ROSA Inc.
Ramapo Organized for Sustainability and a Safe Aquifer
PO Box 712
Pomona, NY 10970

January 7, 2013

RE: Comments regarding Patrick Farm NYS DEC Applications

Culvert #1 - Road B Stream Crossing North of Pond Dam

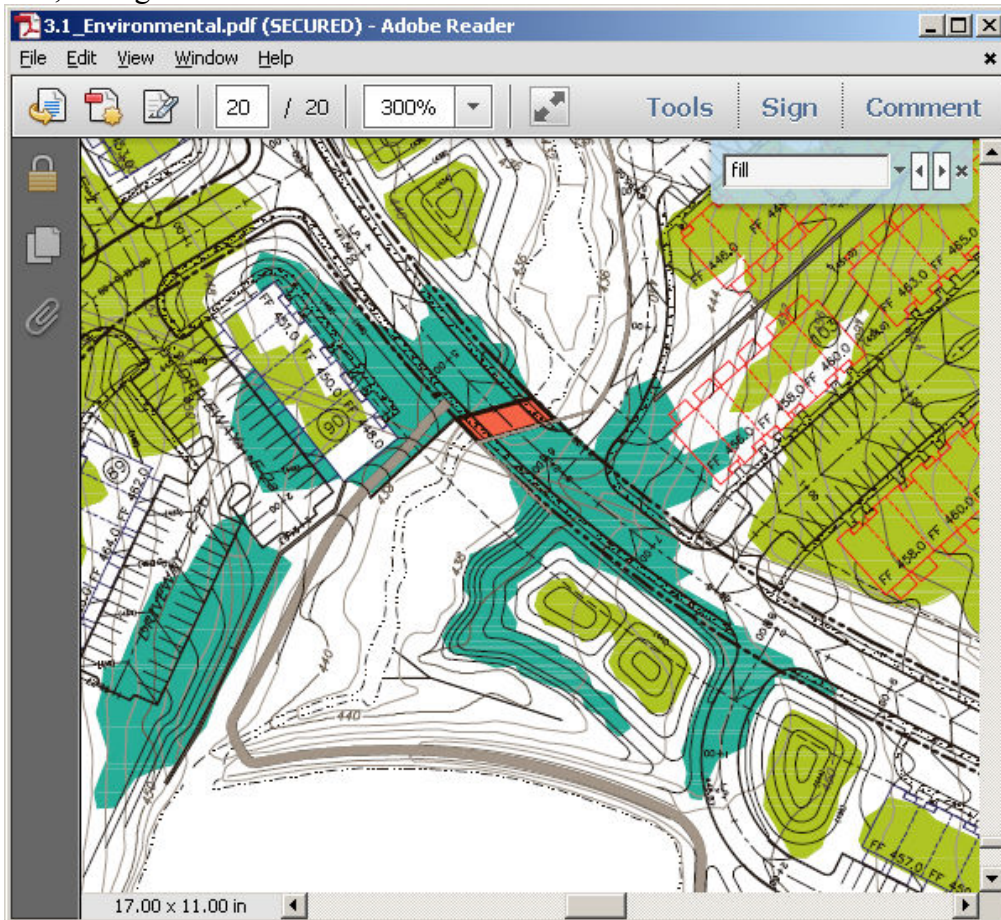
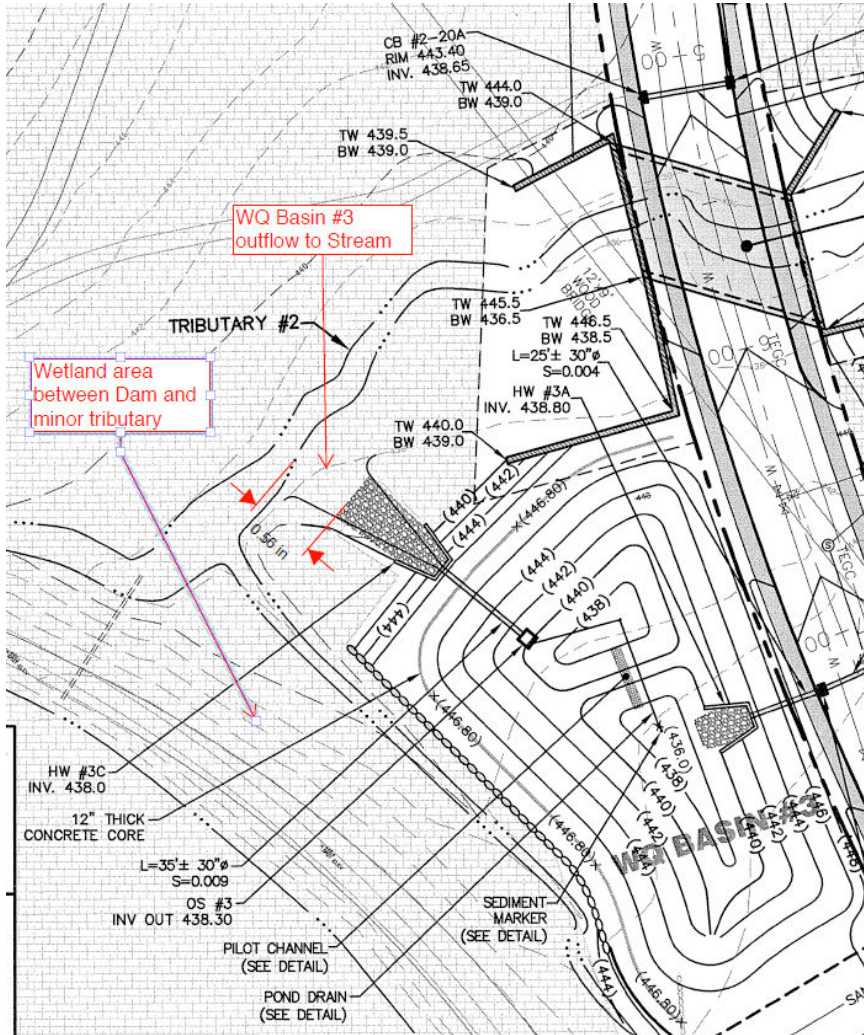
Current application does not show cut and fill plans but show that this culvert is still planned in the same location. Area on north side of dam has wetland properties and should be evaluated prior to approval.

The following screen shot shows a planned stream cross across Class B Stream from Pond. It was taken from section 3.1 of the DEIS Figure 3.1-7 Cut and Fill Analysis Map; dark green = fills, lime green = cuts.

Following is an extract from the final Subdivision Plan Drawing #14 showing that this culvert is still planned for the project. This cu

Along Stream North of Pond

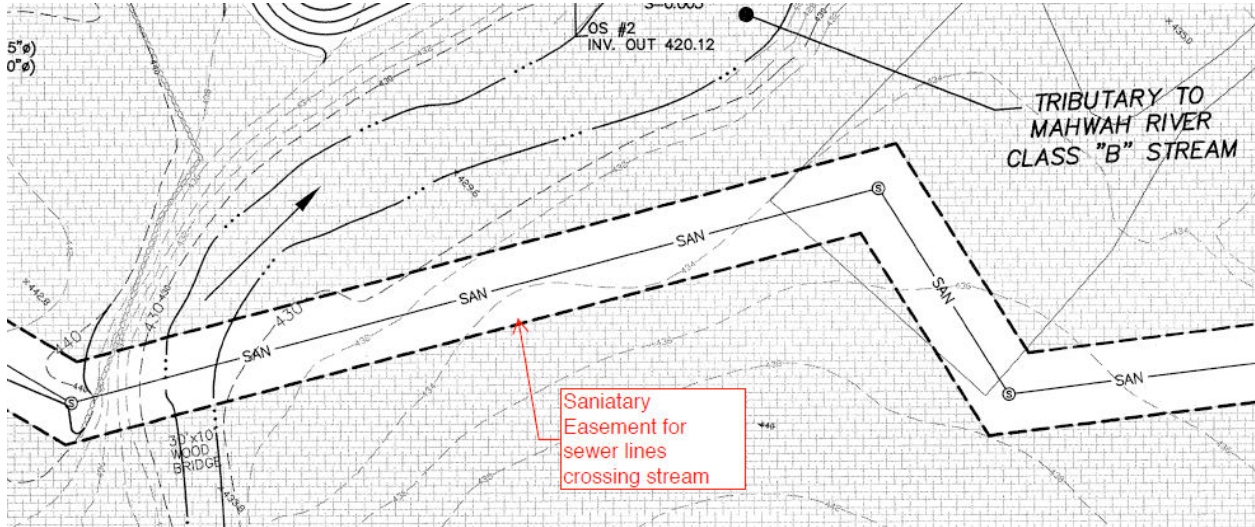
North of the pond dam but south of Location B there is a sewer line crossing the stream near building #54. This is taken from final subdivision plan drawing #14

Immediately north of dam is a minor tributary to the class B stream and this flat area is a potential wetland area. Water Quality Basin #3 is located here with an outflow located ~25' from the main stream. (See above section on WQ Basin #3)

Dam Area Details from Drawing 7 of Condominium Site Plan – Grading and Drainage 1 of 5

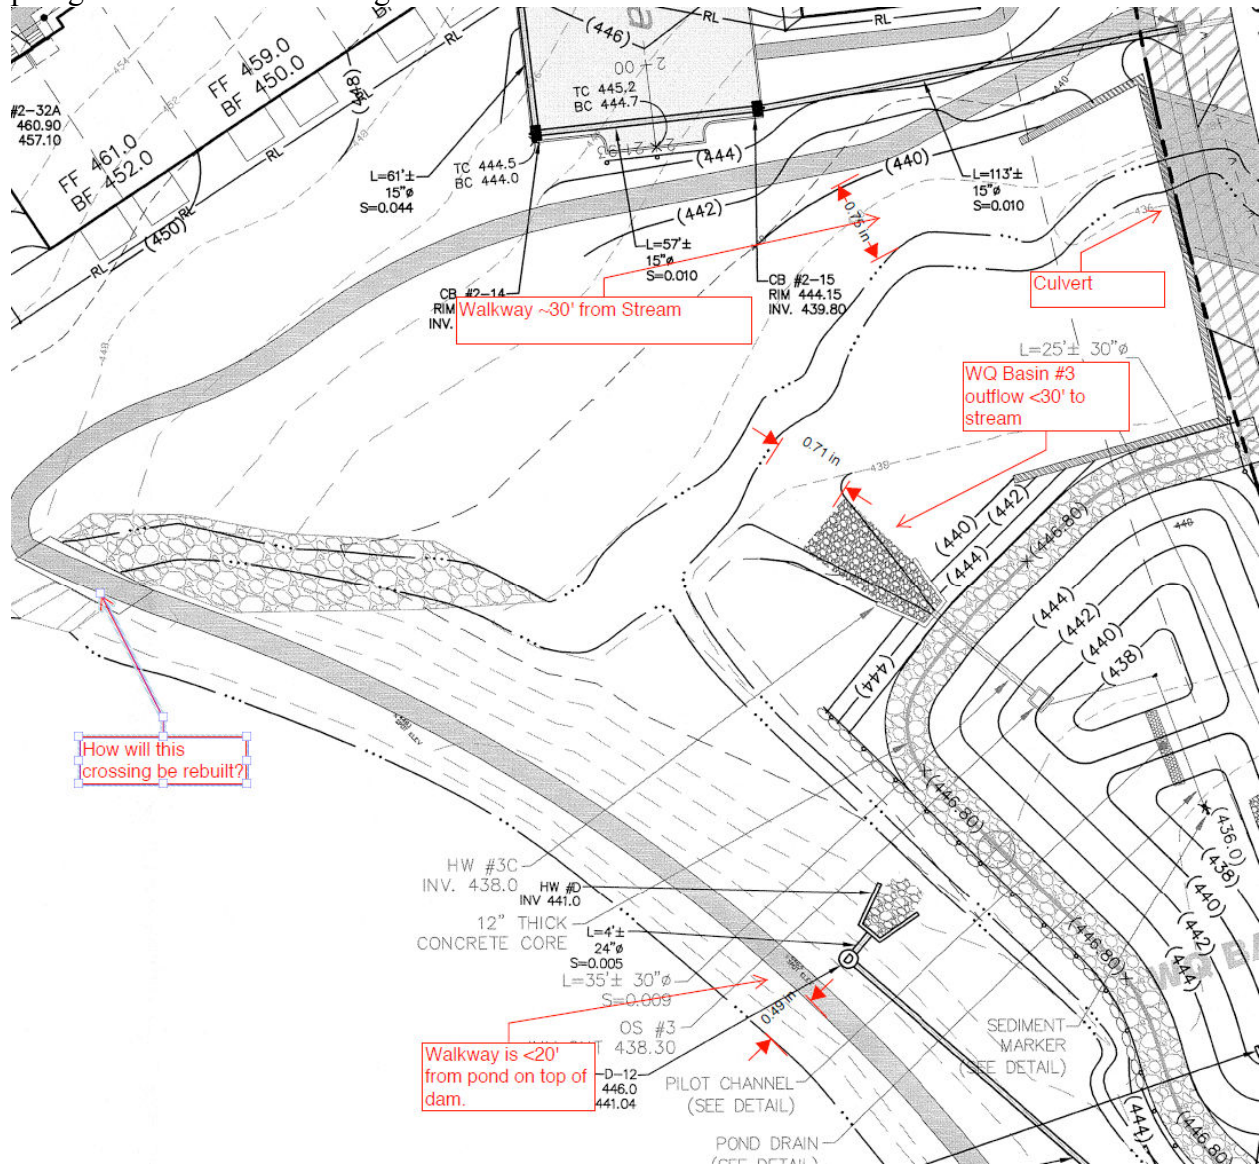
DEC should ask for plans that include 50' boundaries to evaluate the walkway being planned approximately 30' from the stream and <20' from the stream edge, the culvert over the stream, and the drainage from WQ Basin #3. All of this is in an area where there are patches of phragmites and skunk cabbages.

North of Dam Area with Details from Drawing #9 – Grading and Drainage 1 of 5

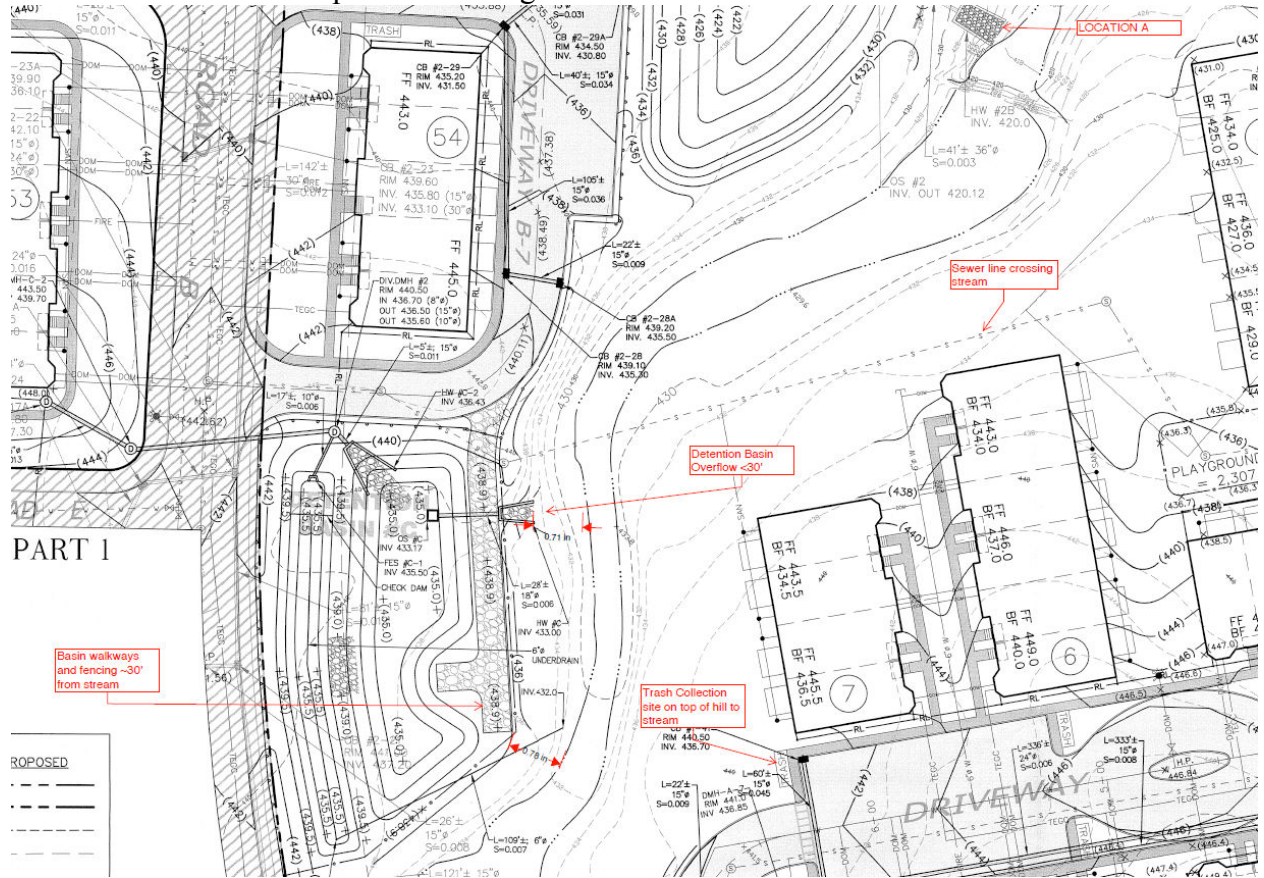
The details below show basin and walkways <30' from stream, sewer line crossing stream and trash collection area at top of hill leading down to stream.

Playground, Buildings, Road, Utilities to the east of Pond in Willows Wetland Area - Details from Drawing 7 of Condominium Site Plan – Grading and Drainage 1 of 5

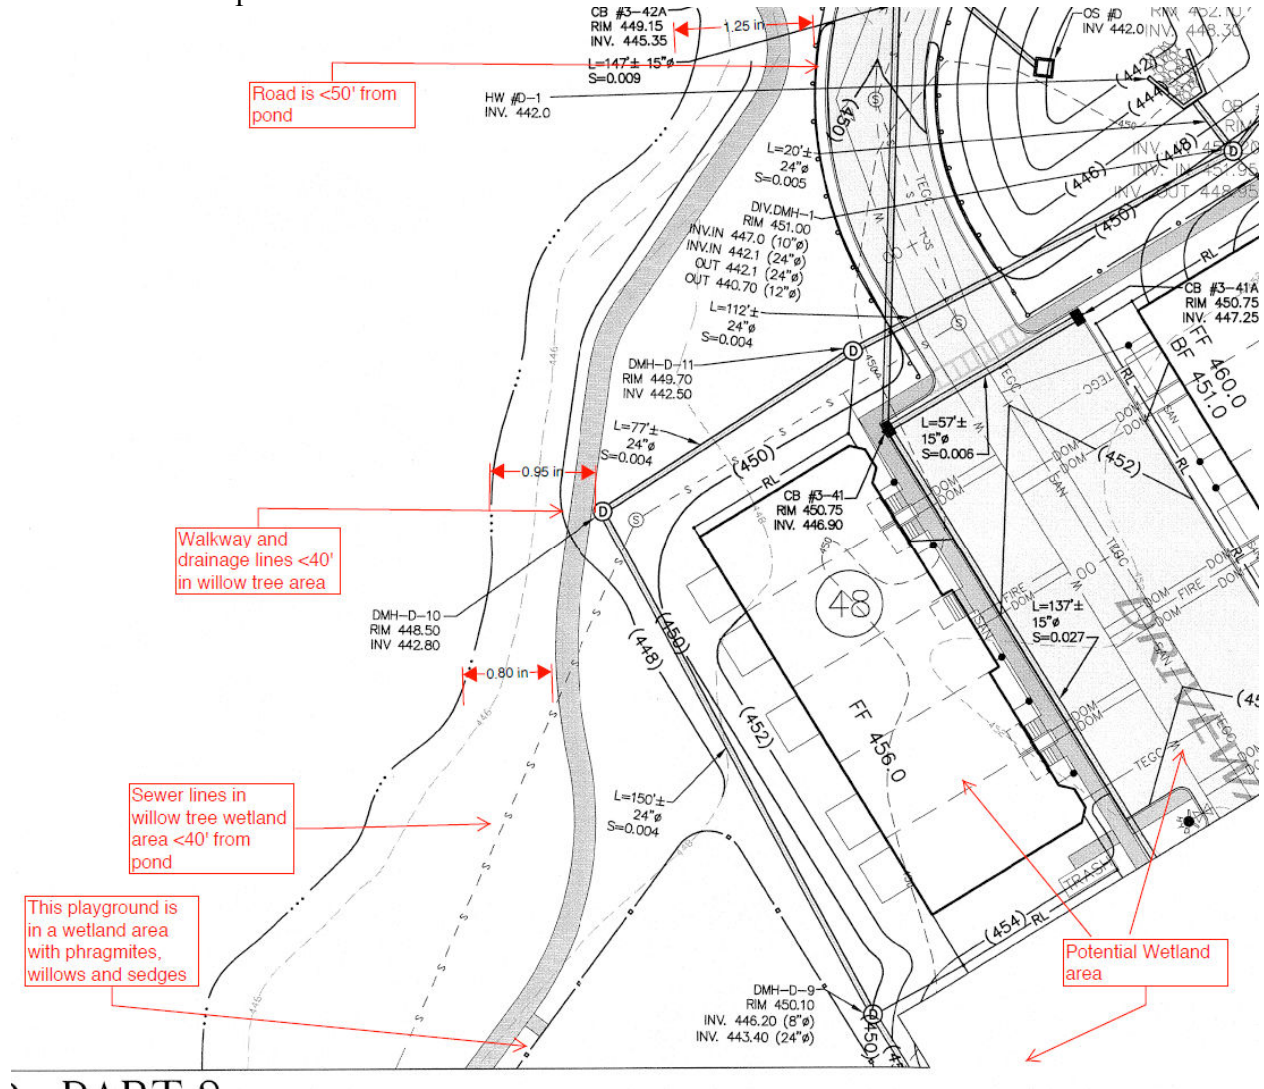
The following shows a road still <50' from pond edge, walkway and sewer lines <40' from pond edge and in area of large willow trees, and playgrounds, buildings and a driveway in an area where there is dispute over the existence of wetlands.

Areas south and south east of the pond from Condominium Site Plan Drawing #8

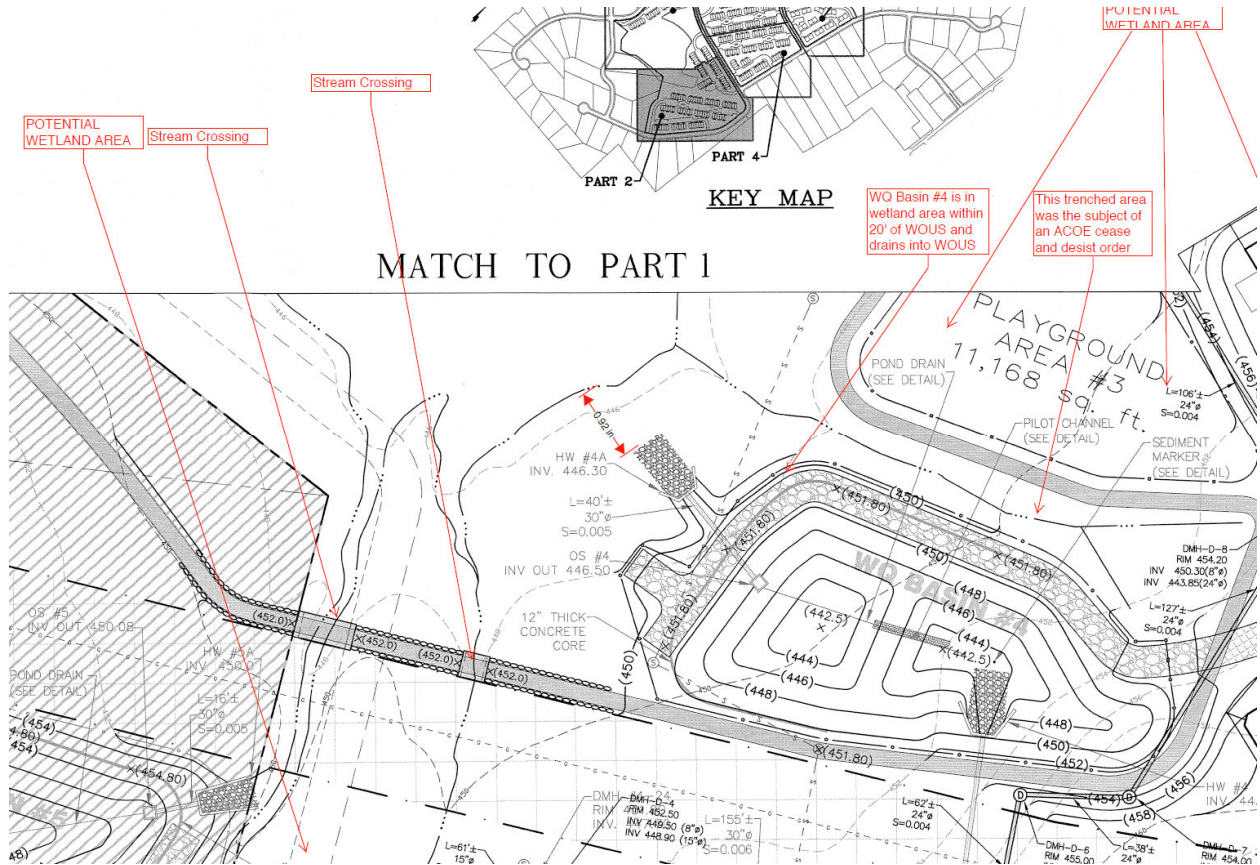
The following shows the detail of the planned development for the area to the south/southeast of the pond where two tributaries converge into the pond in a wetland area. WQ Basin #4 outflows <40' from the pond edge as drawn and is being built adjacent to area subject to ACOE cease and desist order in 2004.

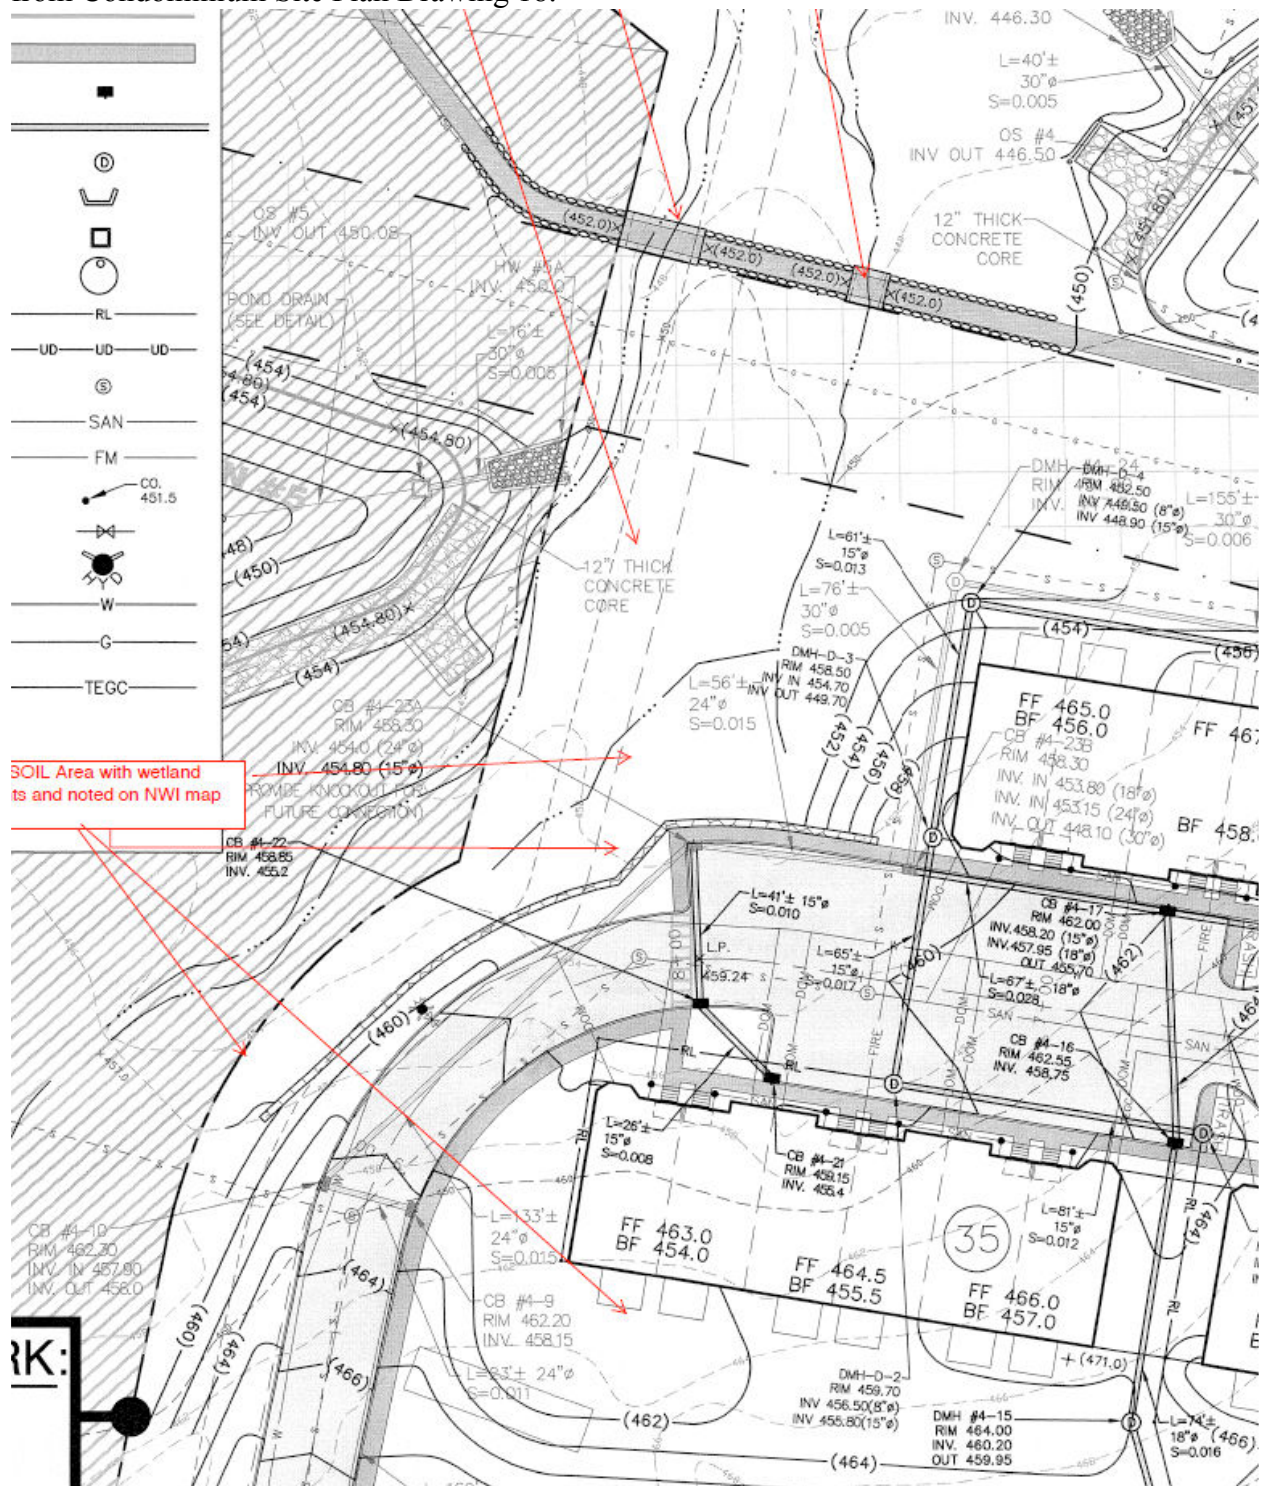
South of this section in areas of Alden soil and where there is a wetland noted on the NWI maps and where wetland plants have been observed there are buildings and road planned. This is also from Condominium Site Plan Drawing 18.
